MEA PARKS SUBSTATION UPGRADES SUMMARY

Birchwood Community Council Meeting: Public Meeting
Beach Lake Chalet

March 11, 2020 6:30 pm to 9 pm

FIGURE 1

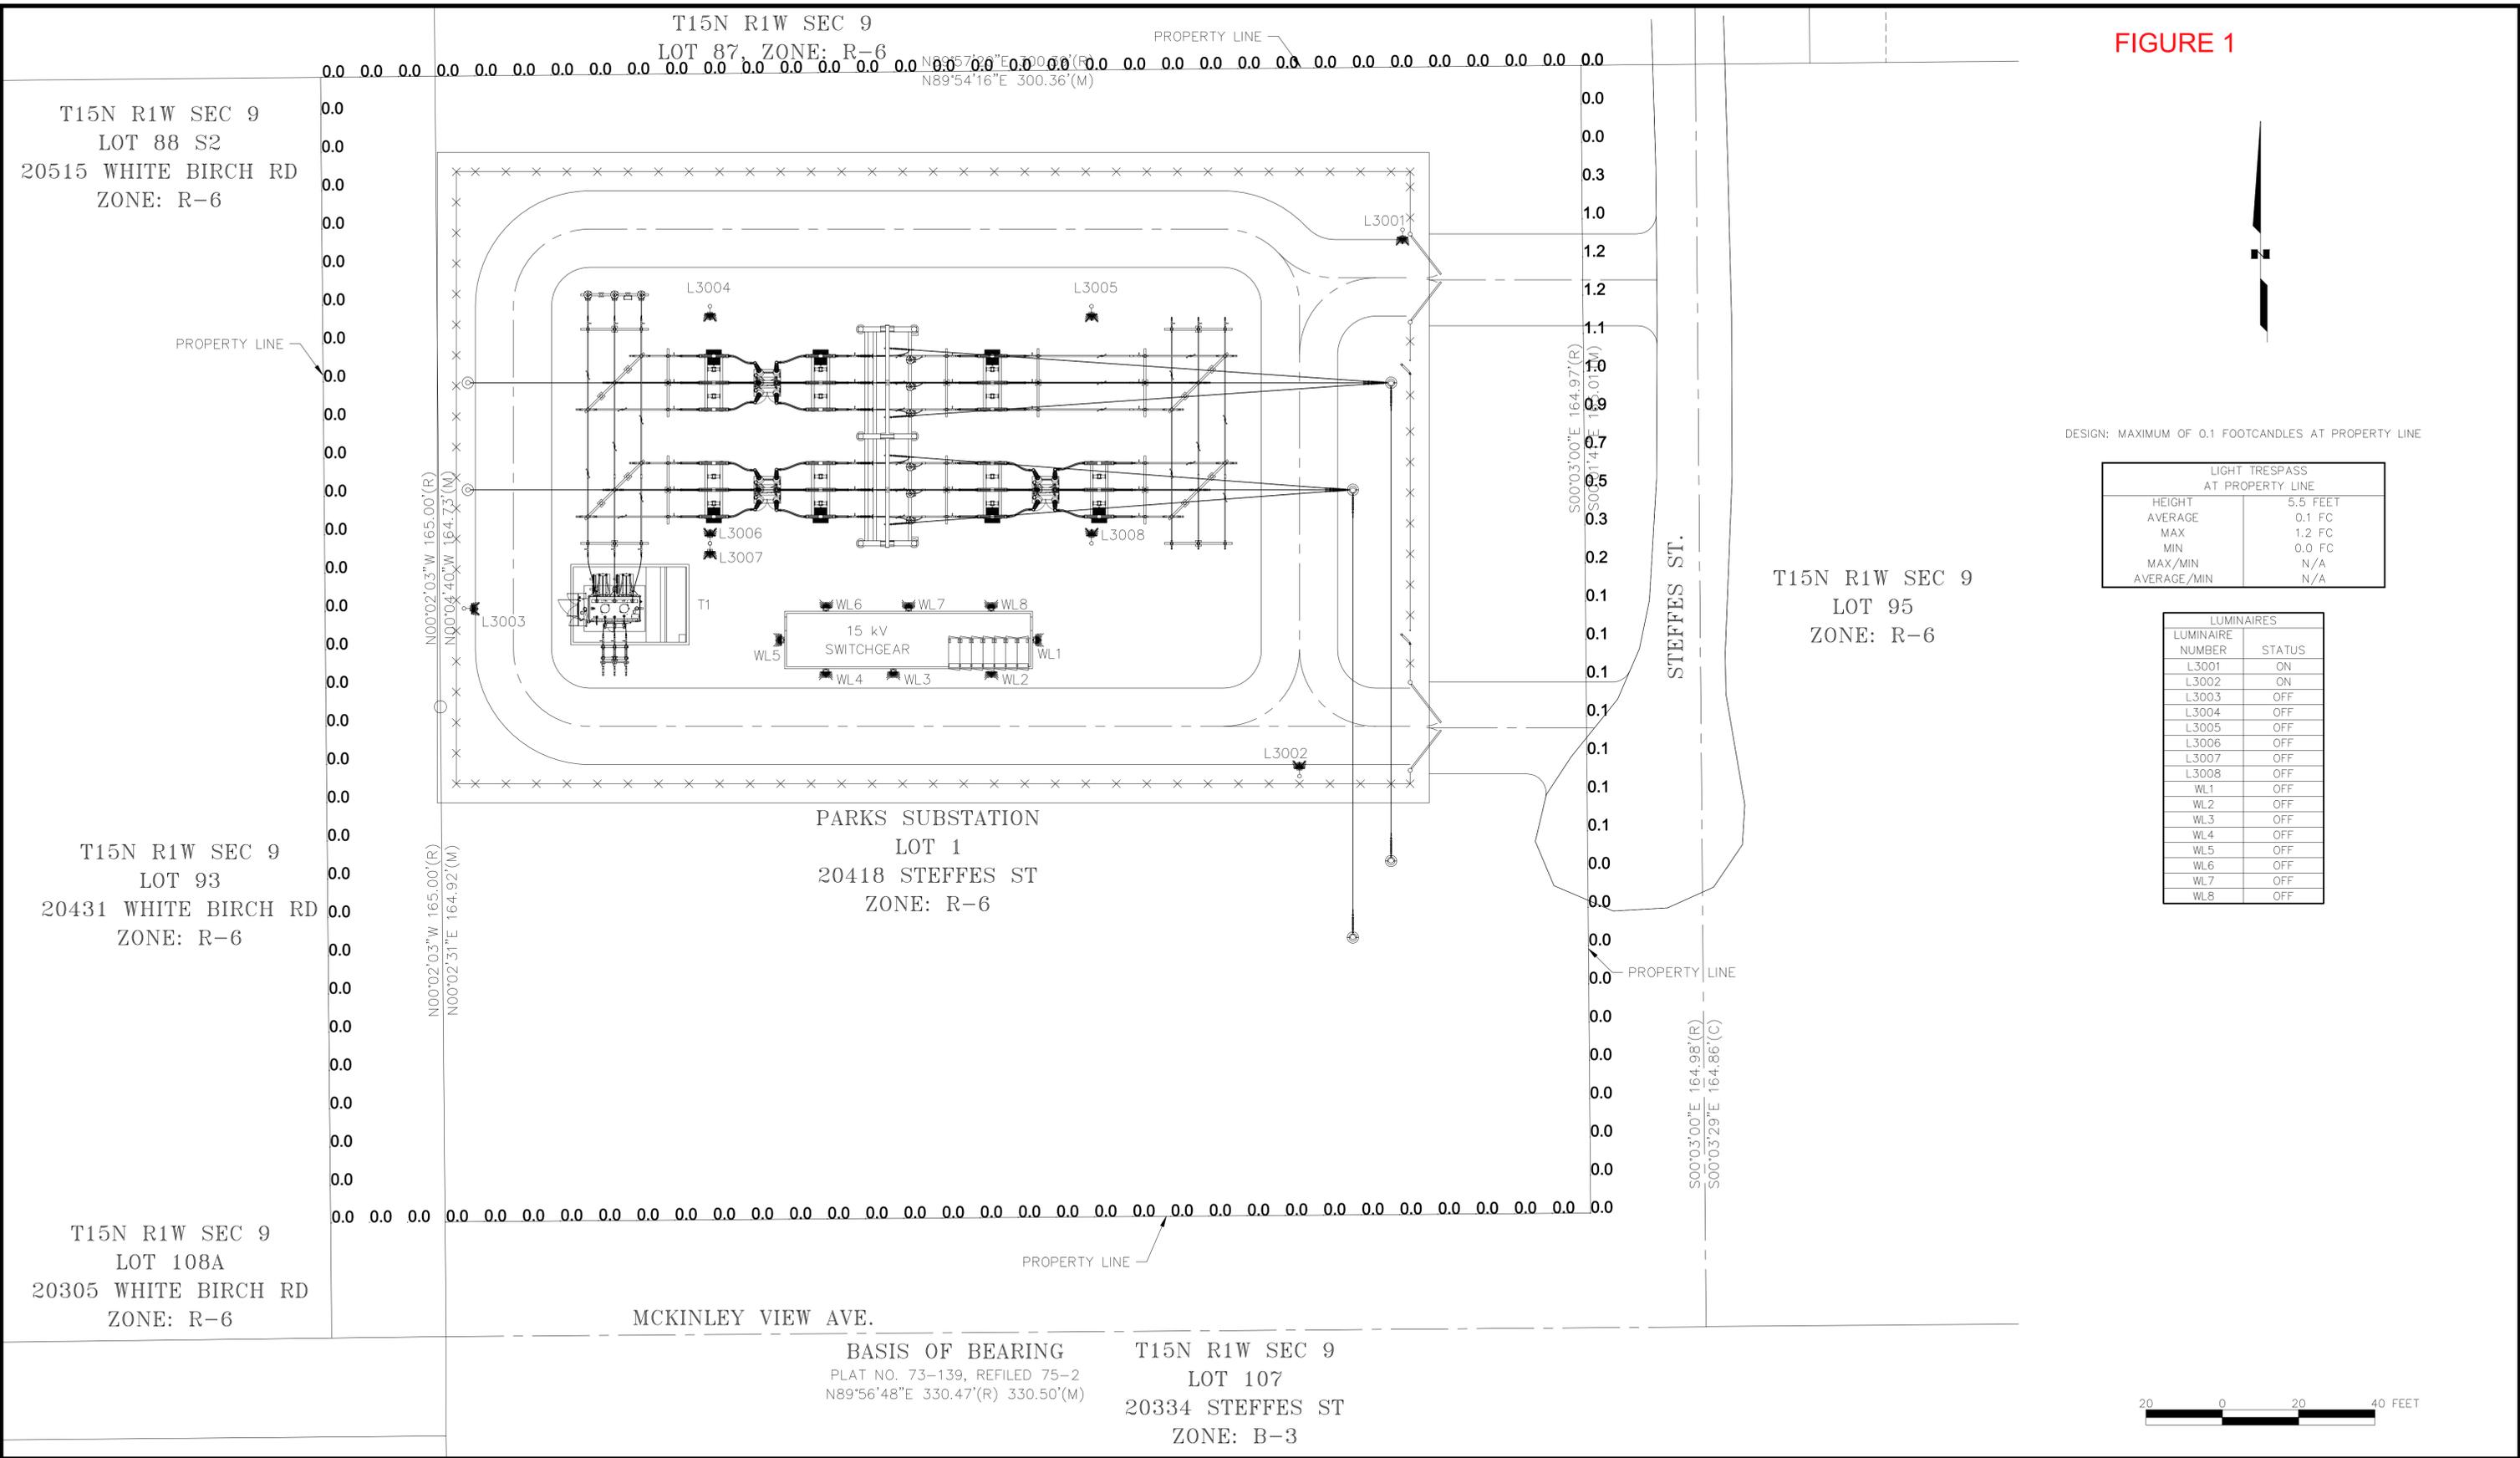
2. Concern about **lighting (off-site light pollution)**

- a. *What are the proposed lumens for the on-site lighting (consistent site lighting and while maintenance staff is on site)?*

All lighting installations will be inside the substation fence. The lighting system will be comprised of *CREE Edge* LED luminaires of varying intensities and will be mounted on 30-foot poles or below the horizon of the 12-foot fence (specifications can be provided on request). All lights will be pointed inward and placed at a minimum 30 feet from property lines. There will be 2 lighting stages, security and maintenance lighting. Security lighting will be photocell controlled and only provide enough lighting to get personnel from the fence gate to the electrical equipment safely. Figure 1 shows the security light trespass at the property lines. Maintenance lighting will be applicable when MEA personnel are in the substation and ambient light is insufficient to perform operations in the facilities. The electrical code requires 2 footcandles (22 Lux) of illumination at ground level and at equipment locations. Figure 2 shows the maintenance light trespass at the property lines. For either light stage, security and/or maintenance lighting, 0.0 footcandles (0 Lux) will be present along the North, West, and South property lines, while the East property line, along Steffes Street, will be at a maximum of 1.2 footcandles.

According to The National Optical Astronomy Observatory (NOAO), the East property line will be comparable to Twilight, which is 1 footcandle (10.8 Lux). At the North, West, and South property lines, it will be comparable to a quarter moon night or darker, which is 0.001 footcandle (0.0108 Lux).
